# FPUD JOB NO. 3095 – SMRCUP Construction

## ADDENDUM D

June 26, 2019

This Addendum "D" includes clarifications and/or changes to the Contract Documents for the Fallbrook Public Utilities District, **Santa Margarita River Conjunctive Use Project Construction**

DRAWING NO.	C-16
SHEET NO.	31 OF 387
CLIENT JOB NO.	2744

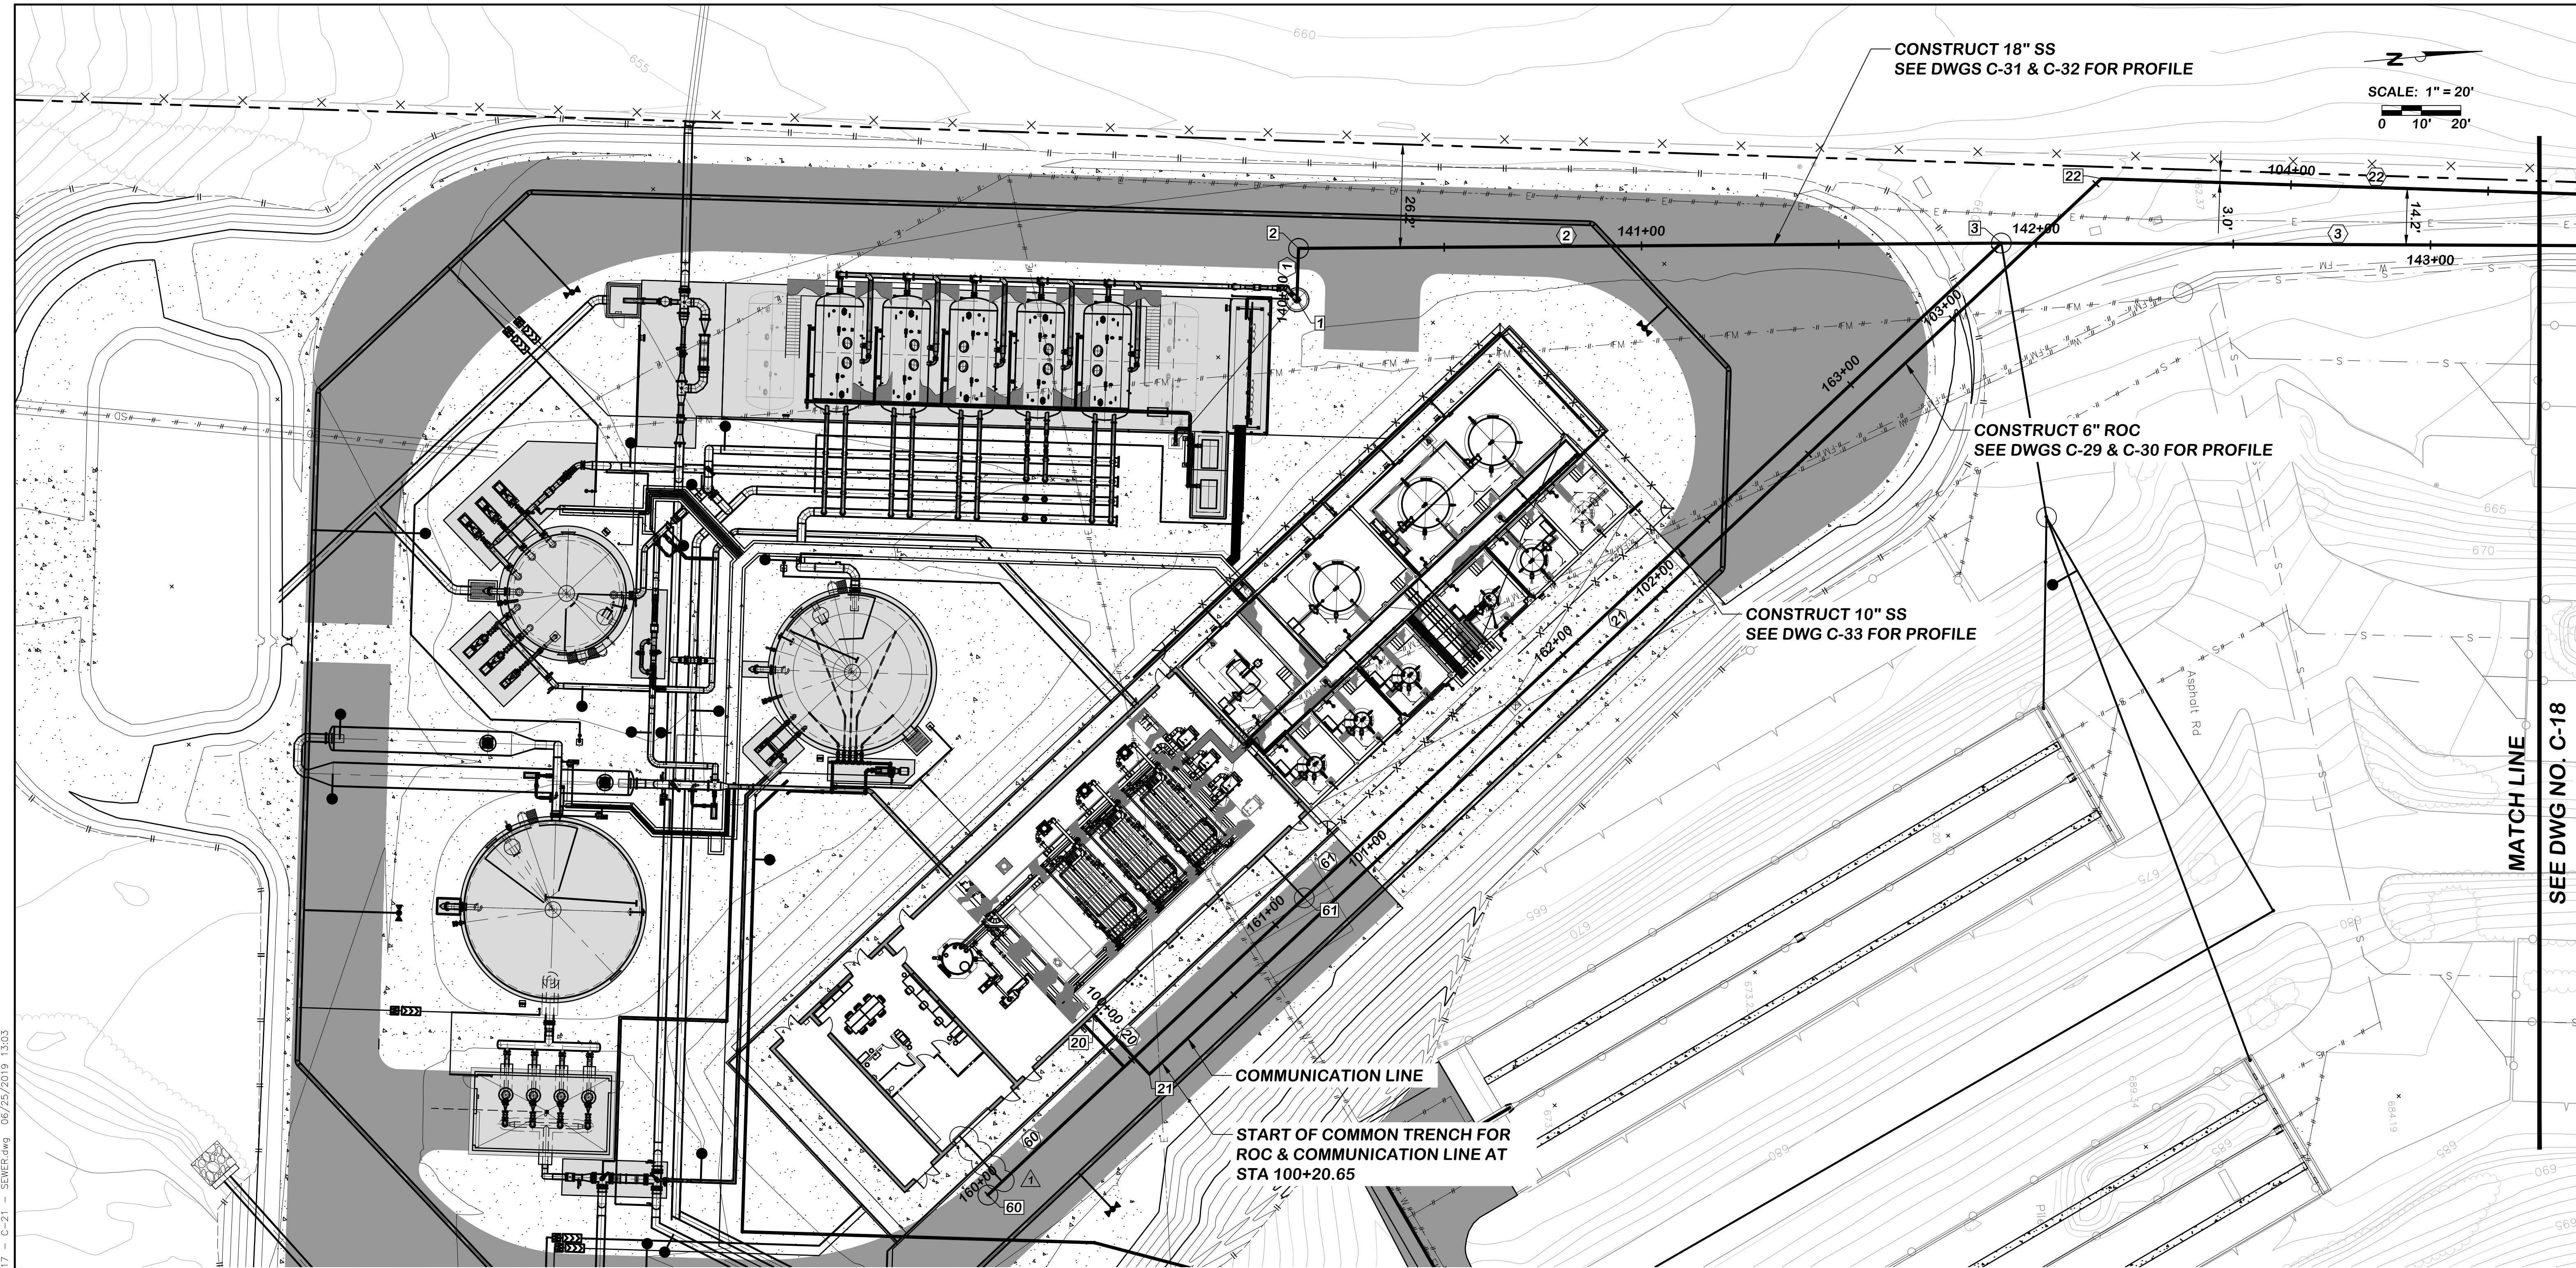
13	Please provide a specification for Metal Decking.	Specification Section 05311 - Steel Metal Deck is provided by addendum.
14	On drawing sheet C-16, note 2 on detail 1 states "Eliminate sleeve in core drilled walls. Epoxy coat entire core drilled opening". Please specify which epoxy system shall be used.	<p><b>Make the following modifications to the Contract Documents:</b>  REMOVE NOTES 1 through 3 and REMOVE Note "Pipe through wall or floor, or ceiling, See Drawings" on Detail 1, Sheet C-16.</p>

DRAWING NO. <b>GE-2</b>
SHEET NO. <b>296 OF 387</b>
CLIENT JOB NO. <b>2744</b>

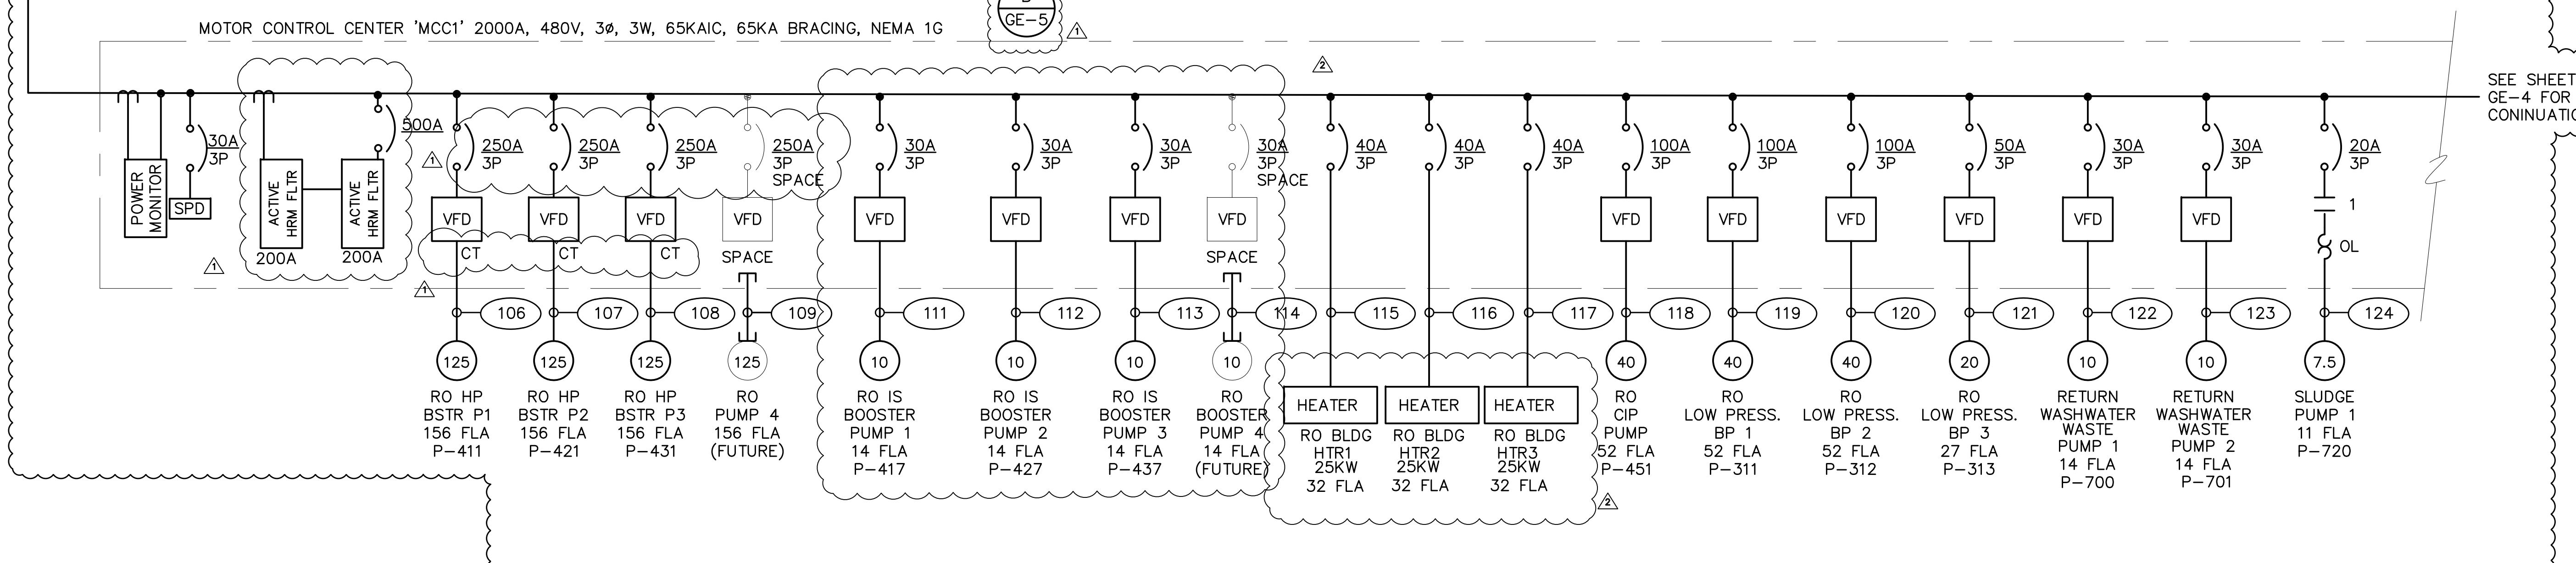
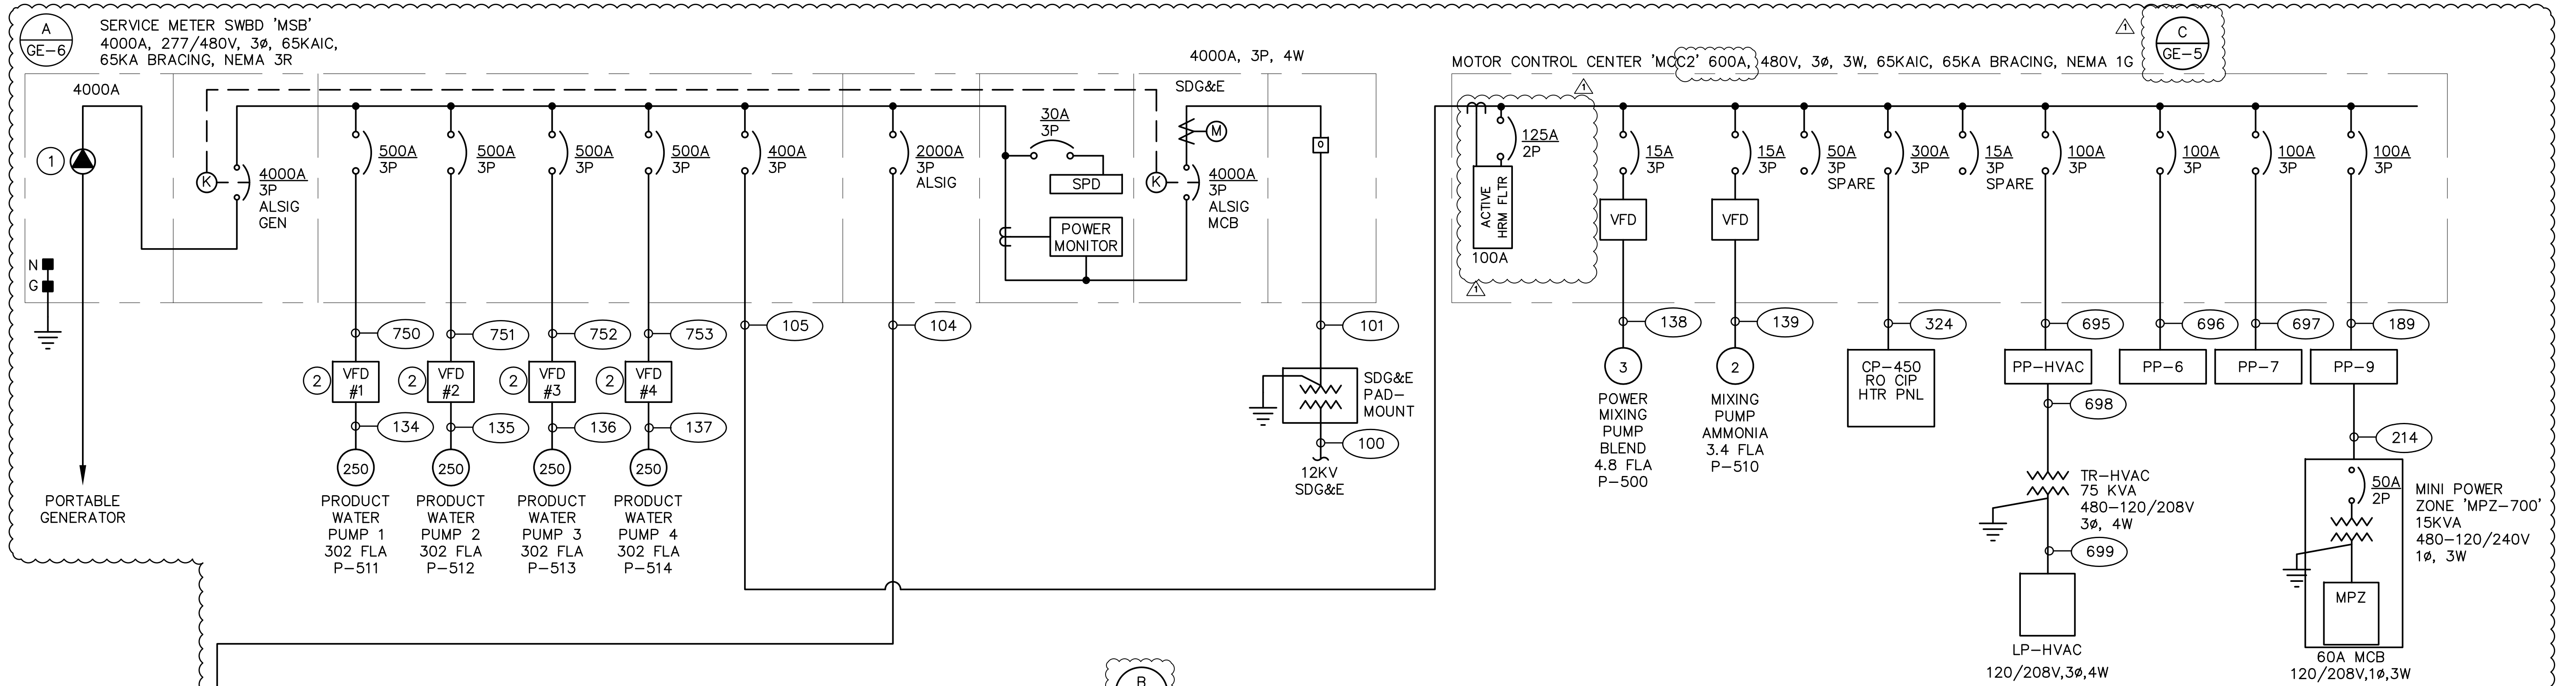
249	Drawing GE-2 shows conduit 749, ( 2" w/FO), in a duct bank grouped with conduits 140, 141, 142 & 690. Drawing 200E shows the continuation of the duct bank but conduit 749 is not shown. Where does it terminate?	Conduit 749 is to terminate in the Network Server room allowing FO cable to attach to Network Rack.
250	Will the Blue-White MD-3 Hybrid metering pump be accepted as an approved equal for Section 11300?	No.
251	Section 11301 Surge Tank-Will Blacoh Surge Control be accepted as approved equal to provide the Bladder Surge Tanks for this project?	Yes.
252	Drawing 200M-2 calls out a 4HF-Titanium60 Spray Nozzle & 500M-2 calls for 2-SH-SS259 Nozzles. Spray System Co. lists the lowest capacity nozzle for a 4HF as 160, not 60. For the SH, the lowest capacity is 250, not 259. Please verify that the SSC sizing is correct.	Nozzle shall be 4-inch flanged (HF) made of Titanium Capacity 160 Spray Nozzle(200M-2). Nozzle shall be 2 each 5-inch flanged (HF) made of Stainless Steel Capacity 250 Spray Nozzles (500M-2).

DRAWING NO. **GE-3**  
 SHEET NO. **297** OF **387**  
 CLIENT JOB NO. **2744**

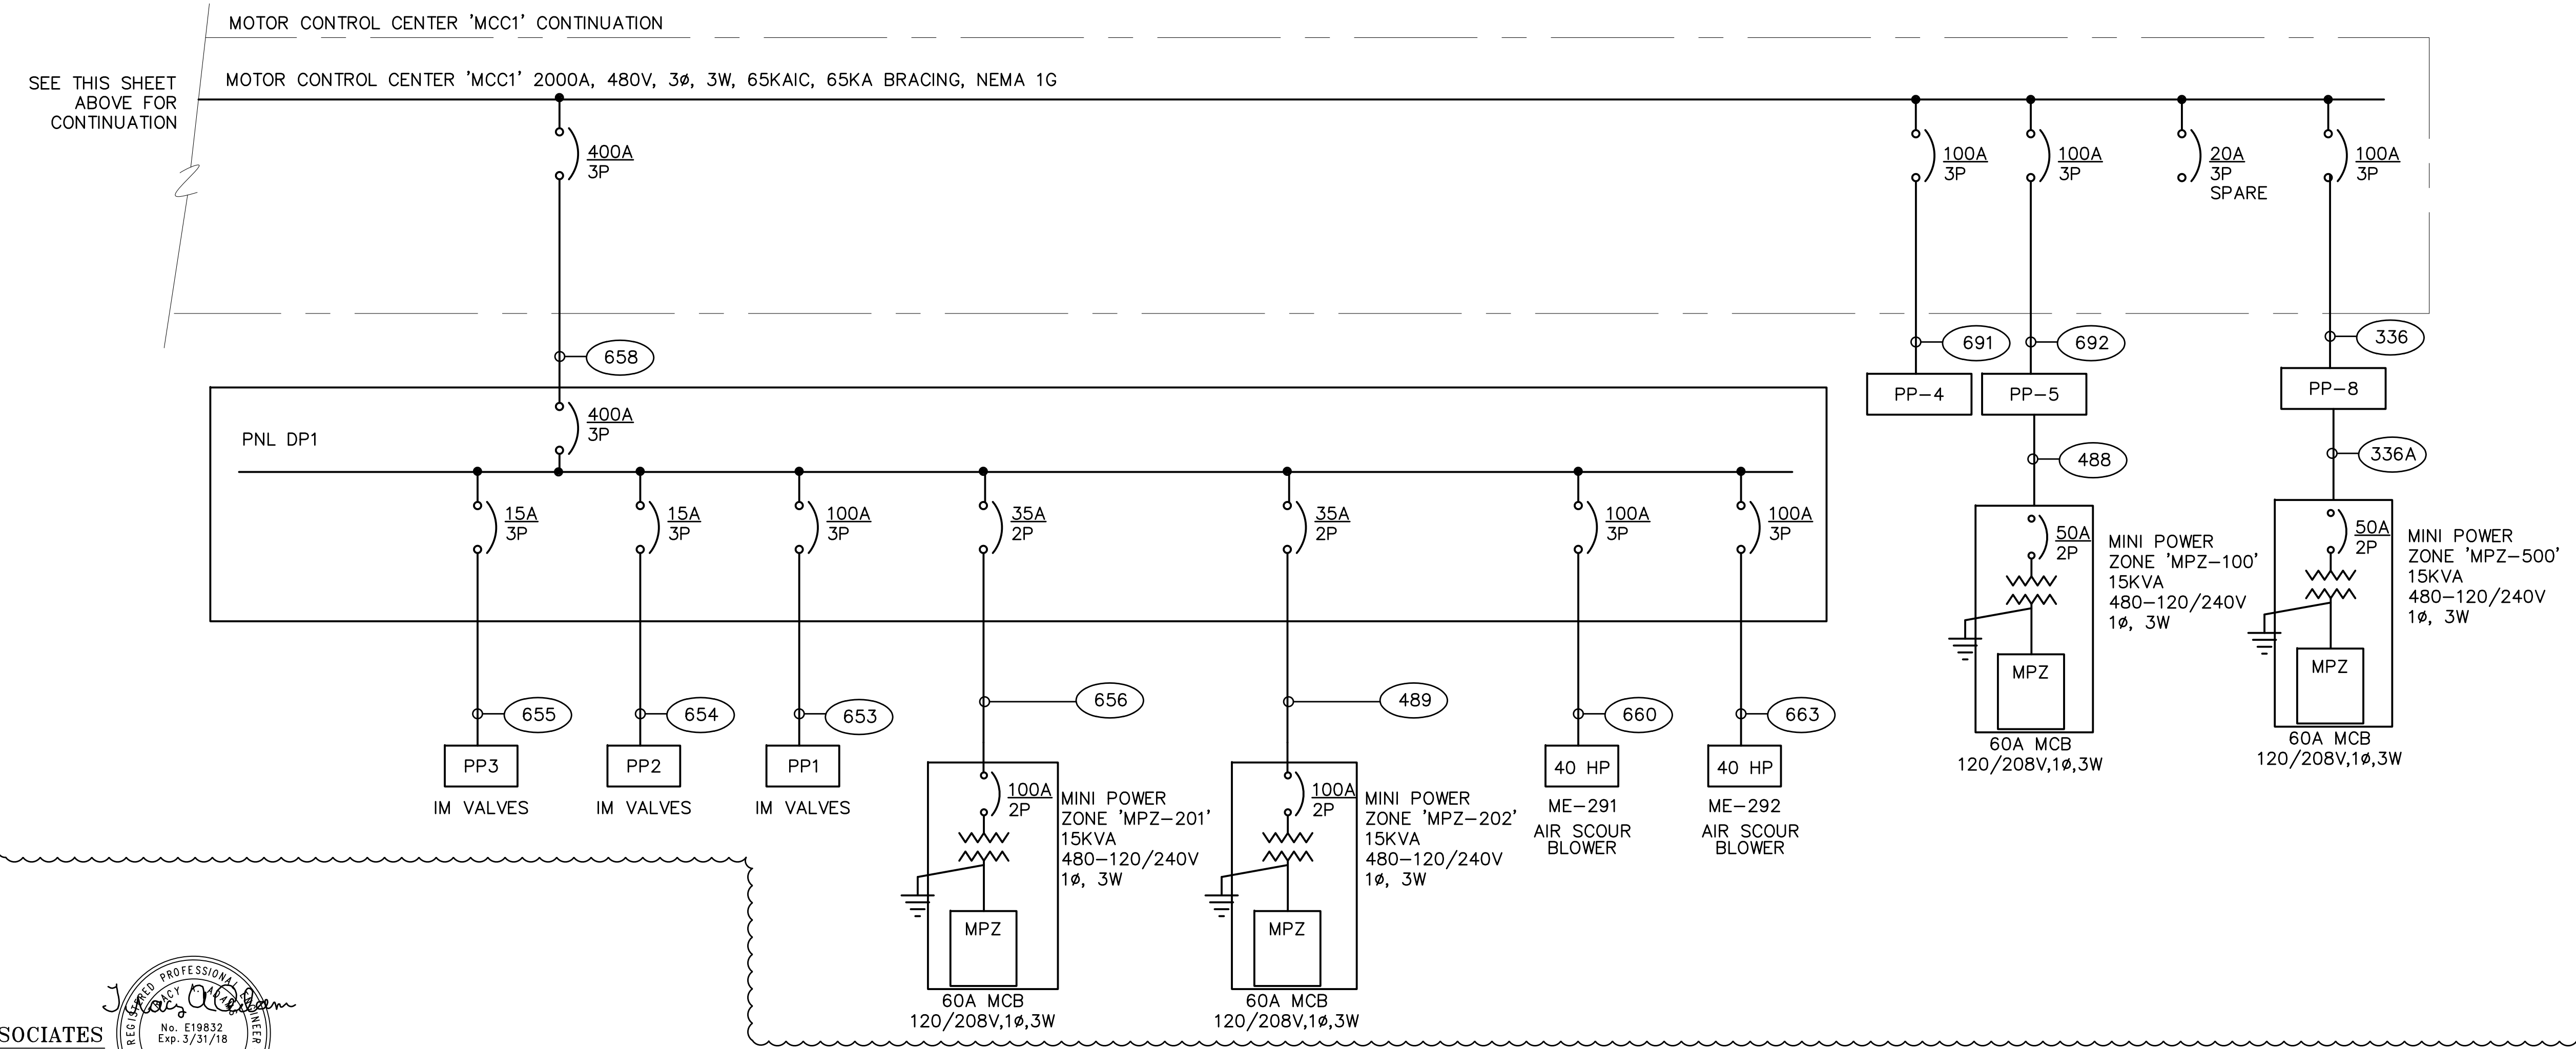
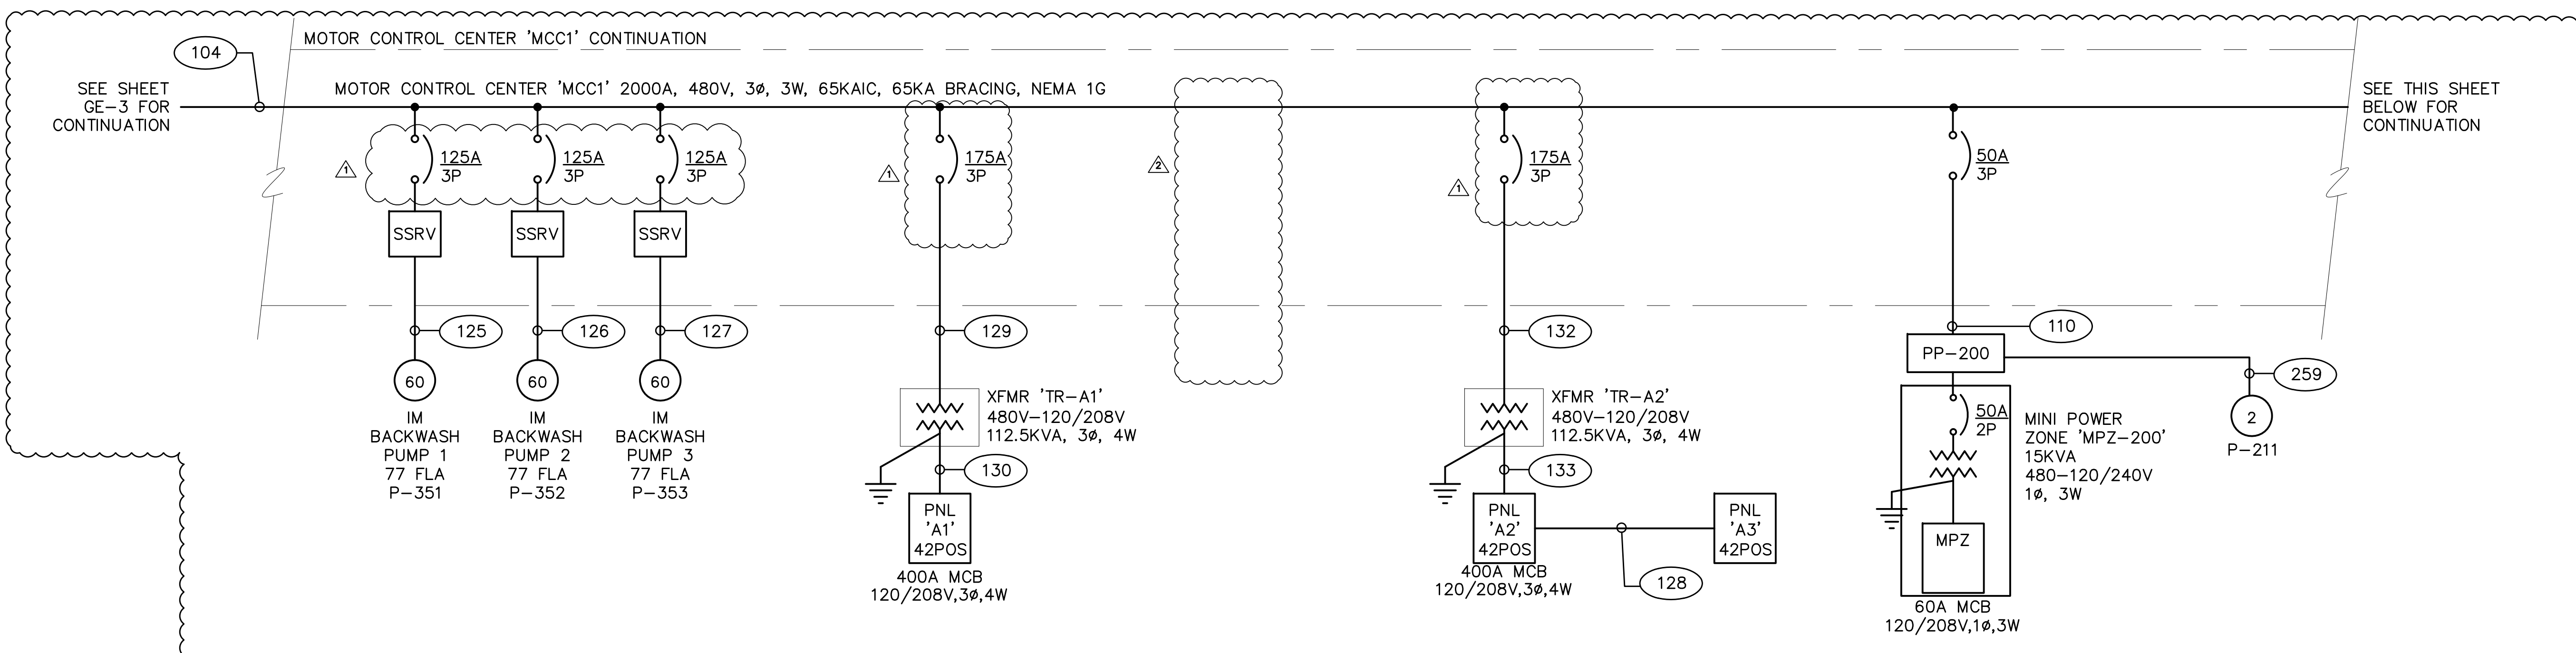
265	Reference single line drawing GE-3. Please provide a control schematic for SSRV RO Booster Pumps. Also clarify if emergency bypass or if standard at speed/run bypass is acceptable for the SSRV's (reference spec section 16290, 2.9.F.1)	RO Booster Pumps 1 to 4 are changed to be equipped with VFD's.
